ADDENDUM 3

PROJECT: 12-22-001 Scoreboards Bid
BID / TIME DUE: Friday, January 20, 2023 at 11:00 a.m. ~~Friday, January 13, 2023 at 11:00 a.m.~~
PAGES: Four (4) pages total

ADDENDUM 3
12-22-001 Scoreboards Bid
January 13, 2023 at 11:00 a.m.

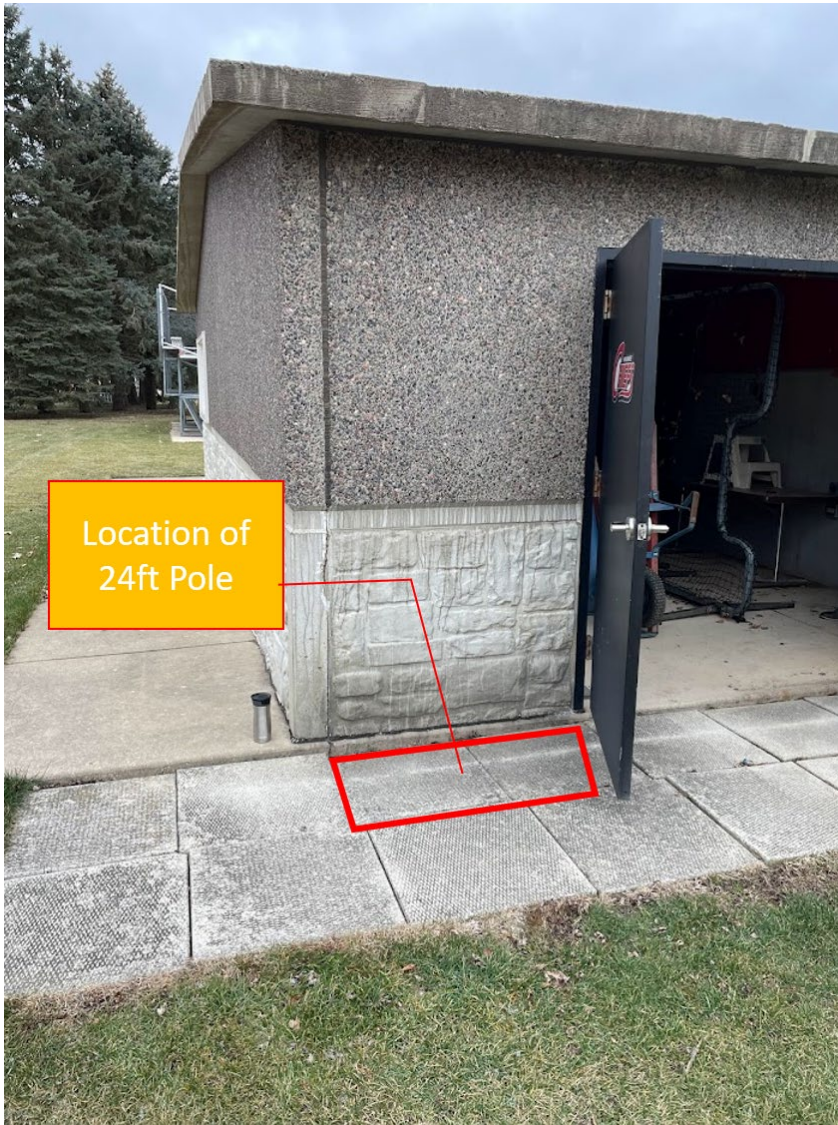
3. Dave Scott (Correct Digital) asked if they can use indoor/outdoor data cables?
 - a. **Ryan Hively (WCC IT) responded yes.**
4. Dave Scott (Correct Digital) asked if the 24 ft, 4" pole can be installed on the west side of the concession stand, removing one of the 2x2 pavers?

- a. **College agreed to this location. See picture found on page 2 of Addendum 3.**
5. Parker Roberts (Parvin-Clauss) asked if the pole should also be secured to the concession stand wall?

Start in Rm 183 (Data)
to
Rm 193 (Electric)
to
Conduit Exit
to
Dugout →

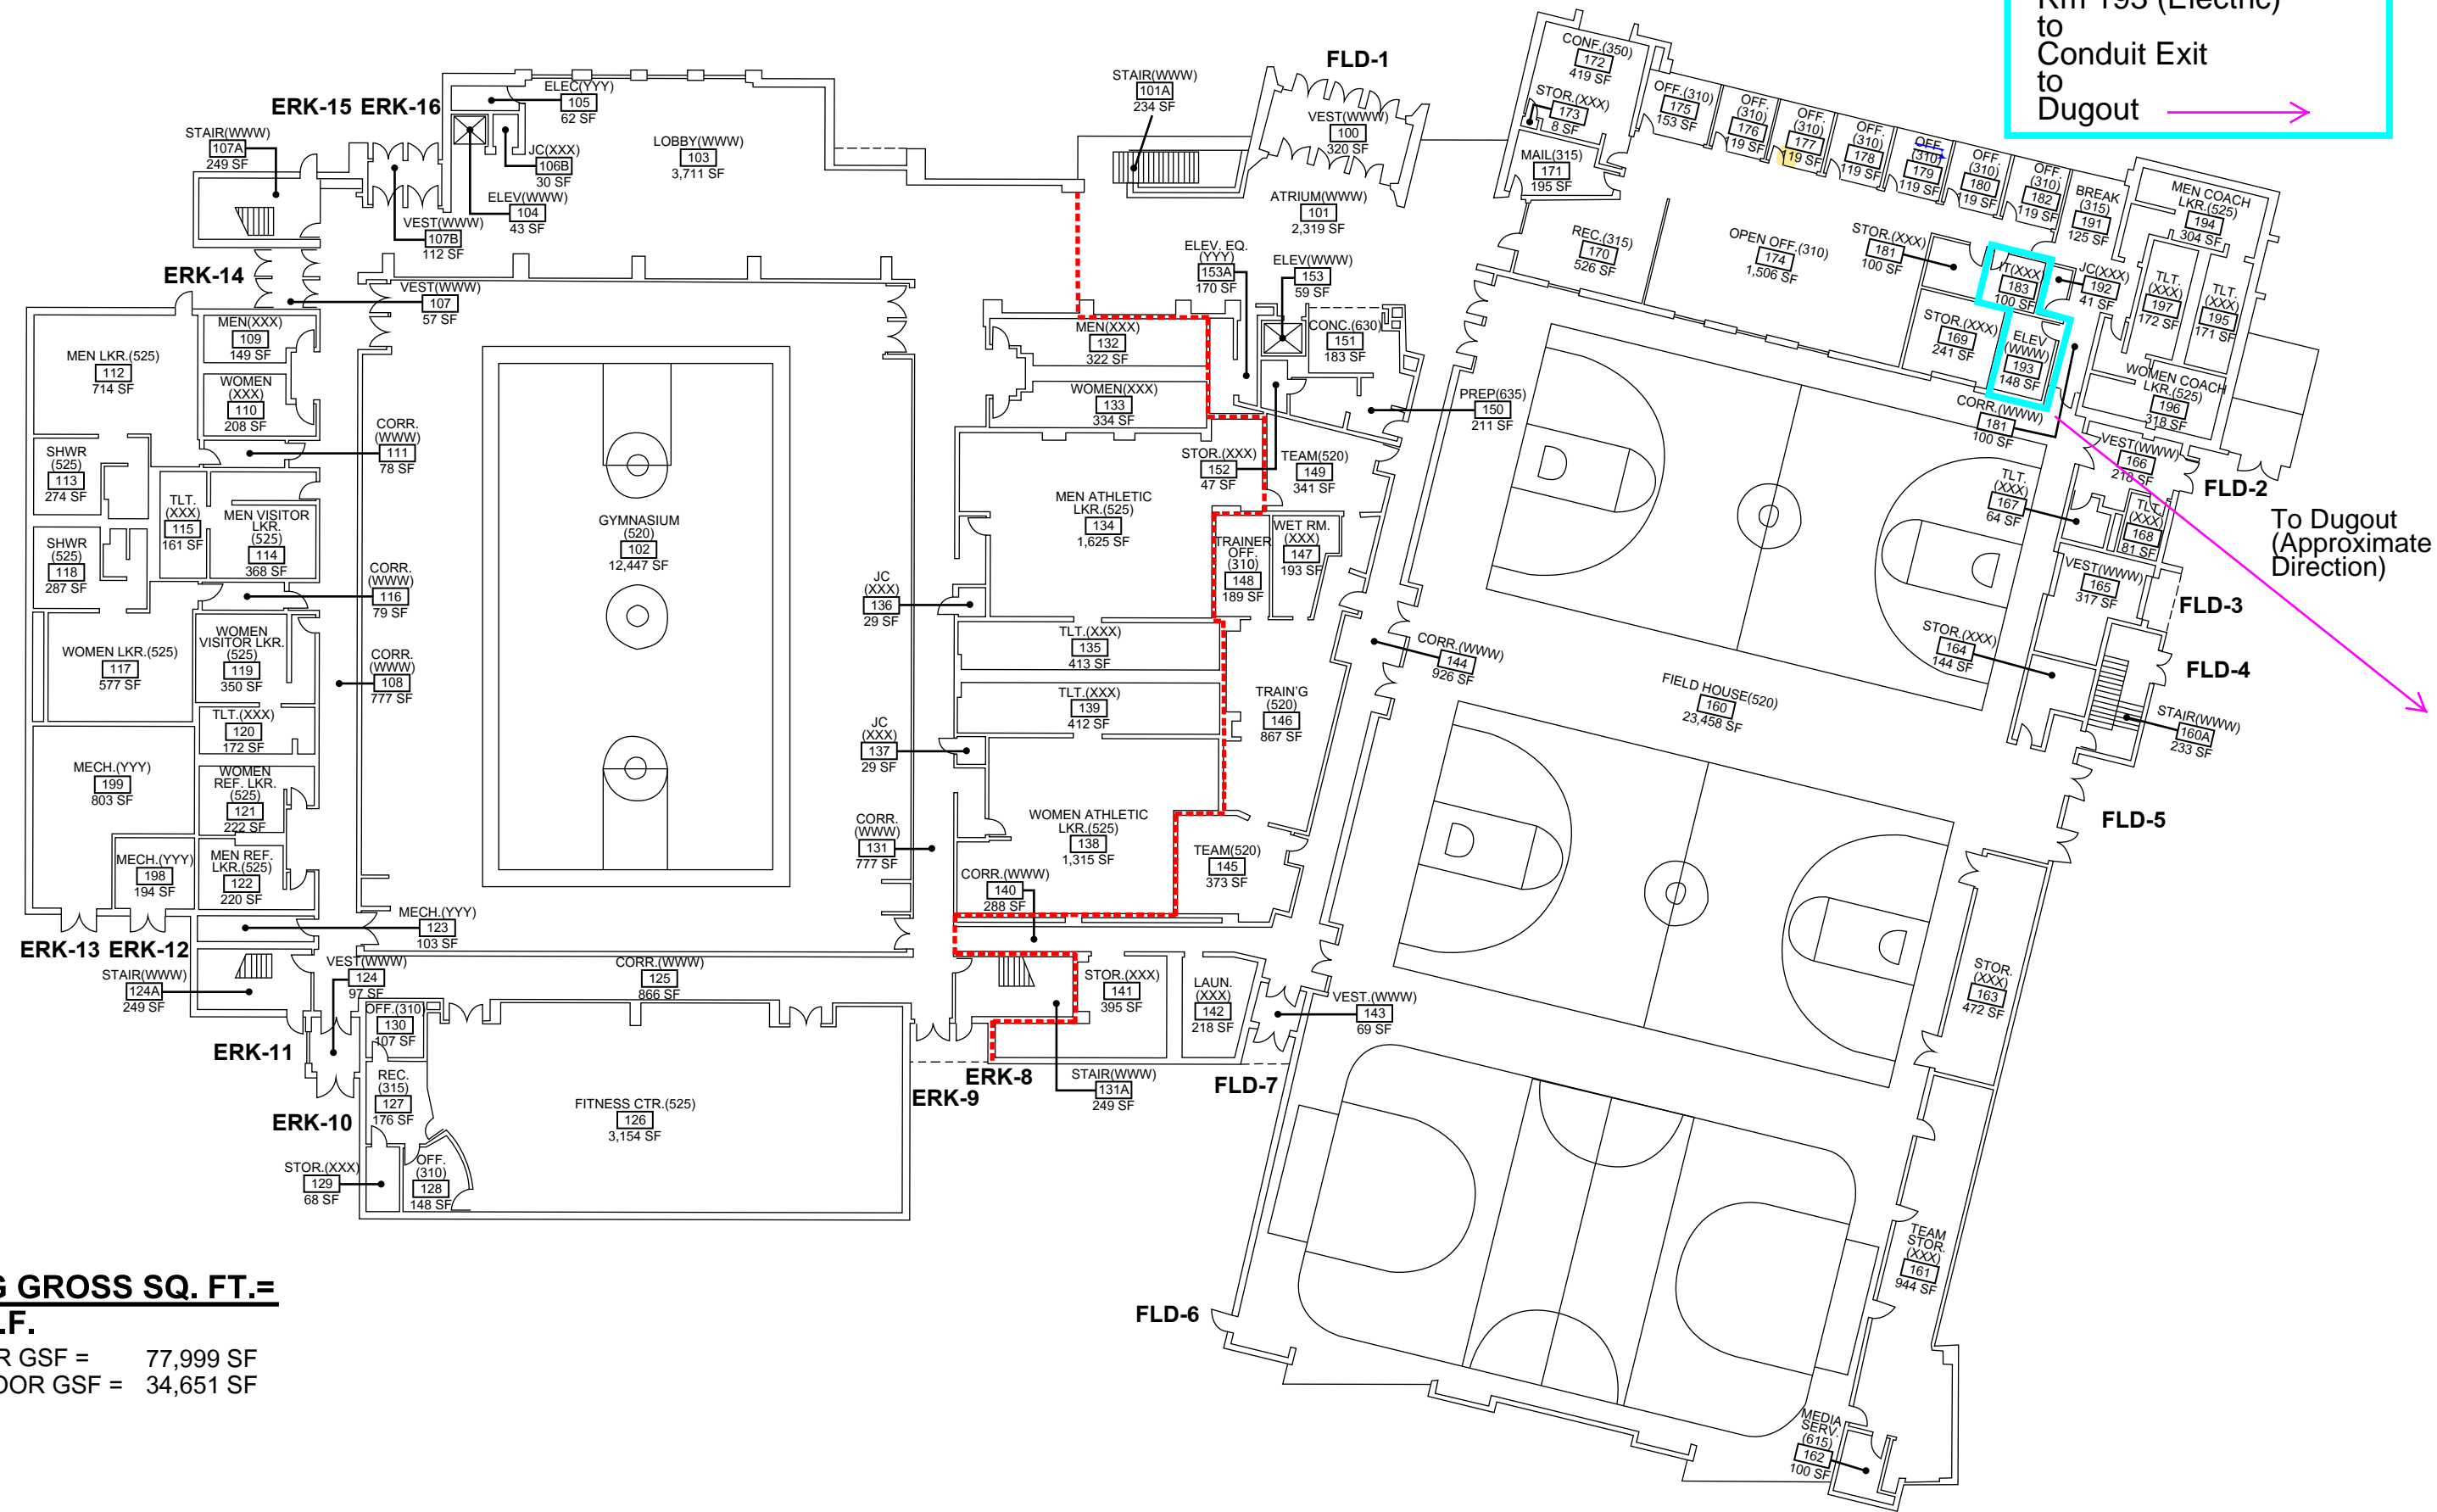
1. Ryan Hively (WCC IT) suggested we include a floor plan addendum to the manual.
 - a. **Please see attached plan with marked rooms: FLD-183 (Data Rm) & FLD-193 (Electrical Rm).**
